| <b>Subject:</b><br><br>HORN SOUNDS BY ITSELF | <b>Bulletin No:</b> 09-024/12  |

## APPLICABLE MODEL(S)/VINS

2013 CX-5 vehicles with VINs lower than JM3KE\*\*\*\*\*110830 (produced February 29, 2012)

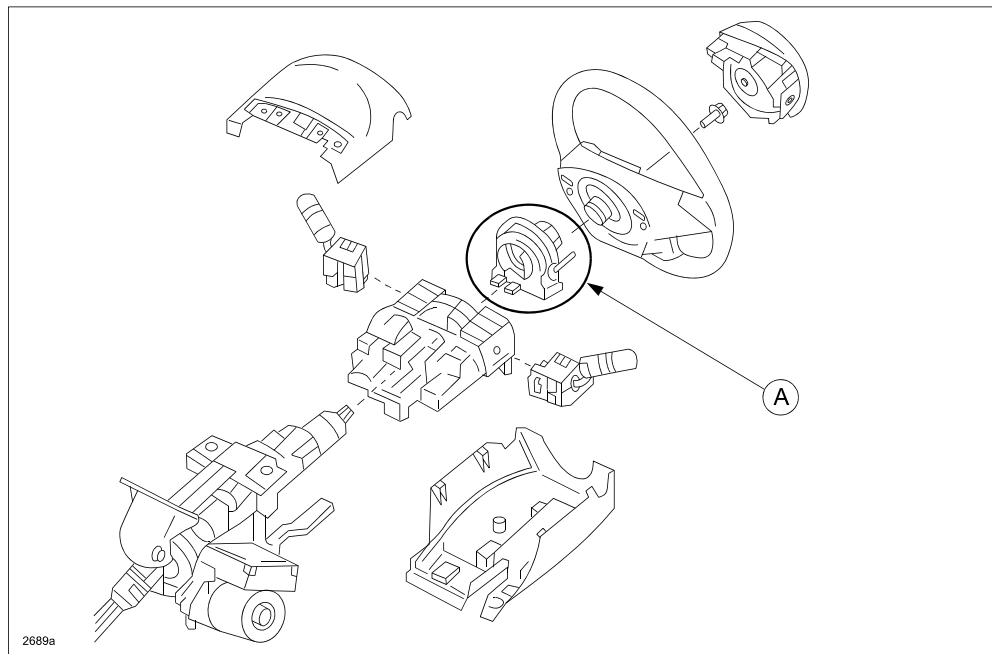
Some vehicles may exhibit a horn that suddenly and continuously sounds by itself. This condition may occur after the vehicle is parked in cold ambient temperatures of 32 degrees F (0 degrees C) or below for several hours, then moved into a warmer shop or garage.

This concern may be caused by an internal short circuit of the clock spring.

1. Verify the customer concern.
2. Inspect the clock spring (A) according to the instructions on MS3 online or the Workshop Manual (section 08-10 CLOCK SPRING INSPECTION [STANDARD DEPLOYMENT CONTROL SYSTEM]) or CLOCK SPRING INSPECTION [TWO-STEP DEPLOYMENT CONTROL SYSTEM]).
  - If any problems are found during the inspection, go to next step.
  - If no problems are found during the inspection, inspect other horn circuits according to MS3 online or the Workshop Manual.

3. Replace the clock spring with a modified part according to the instructions on MS3 online or the Workshop Manual (section 08-10 CLOCK SPRING REMOVAL/INSTALLATION [STANDARD DEPLOYMENT CONTROL SYSTEM]) or CLOCK SPRING REMOVAL/INSTALLATION [TWO-STEP DEPLOYMENT CONTROL SYSTEM]).
4. Verify the repair
